REMARKS:

Serial Number 10/620,228
Attorney Docket No. A3-143 US

Annotated Marked-up Drawings

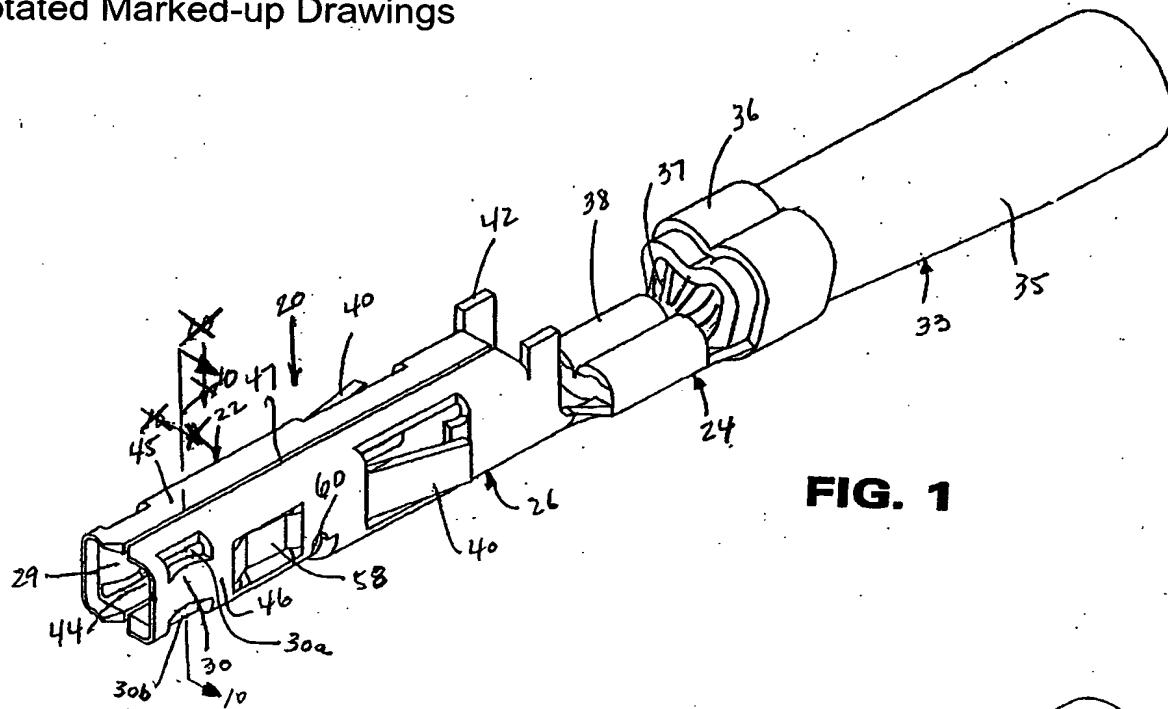
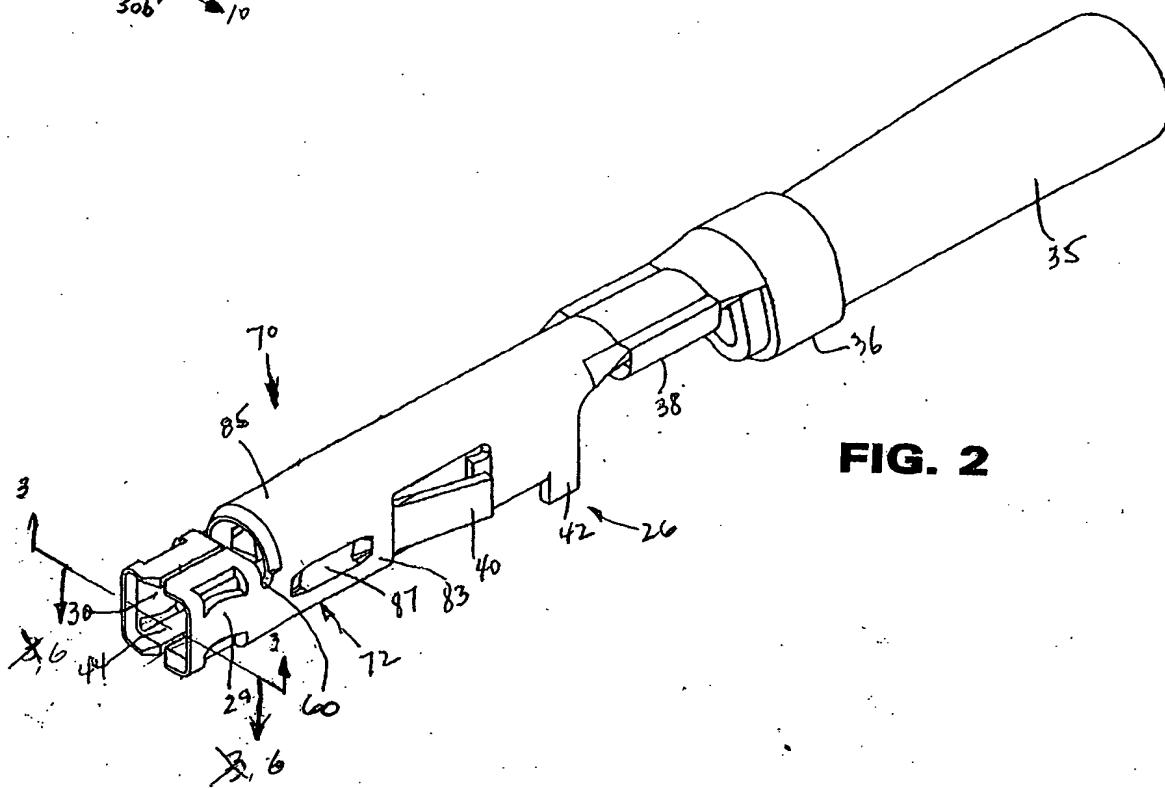
In the Office Action mailed on December 18, 2003, the Examiner objected to some of the drawings as not having proper sectional lines, objected to the abstract as being too long, objected to claims 1, 3, 4, 8, 12, 15, 17, and 26 because of a number of informalities, rejected claims 1-11, 14-25 and 28-31 under 35 U.S.C. section 102 (b) as being anticipated by Chaillot et al. (US 5,989,078), and rejected claims 12, 13, 26, and 27 under 35 U.S.C. section 103 (a) as being an unpatentable combination of Chaillot et al. (US 5,989,078) in view of Ito et al (US 5,630,738).

Attached are two copies of sheet 1 of the drawings. One sheet has the changes highlighted and the other sheet is a clear copy of the drawings as amended which should replace the original sheet 1..

With this amendment sheet one of the drawings has been replaced with a corrected drawing, the abstract has been replaced with a new shortened abstract, and claims 1, 3, 4, 8, 12, 15, 17, and 26 have been amended. Claims 1-31 remain in this application.
